COA 17-25

518 N 2nd Street

Consideration of an approval for the replacement of the existing metal shingle roof with 5V Crimp metal panel roof, and replacement of upper level wooden windows with vinyl high impact windows.

HISTORIC PRESERVATION BOARD : PUBLIC HEARING

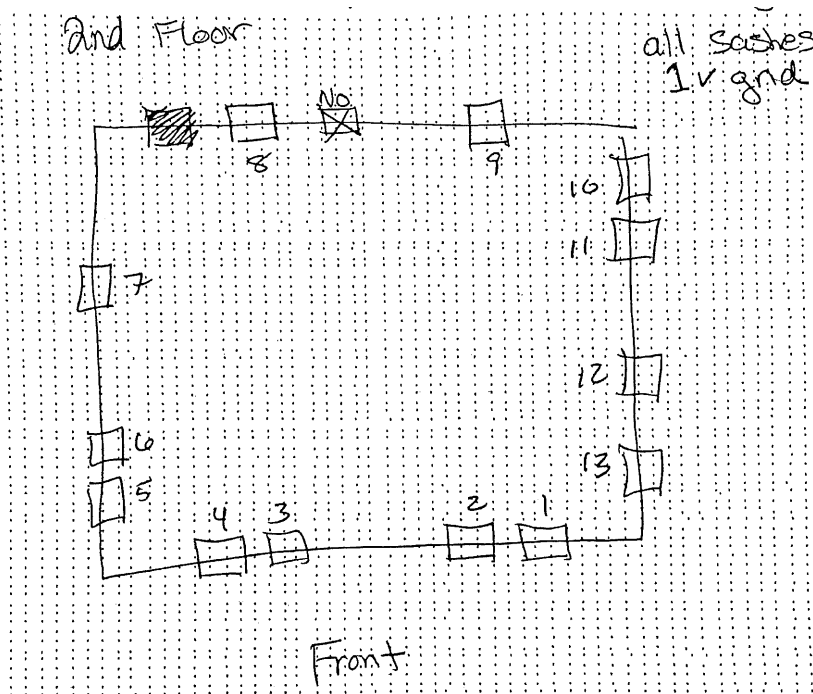
- replacement of the existing metal shingle roof with 5V Crimp metal panels to match the existing rear addition.
- replacement of all upper level wooden windows (13) with vinyl high impact windows to match existing design and preserve the integrity of the applicant historical home.
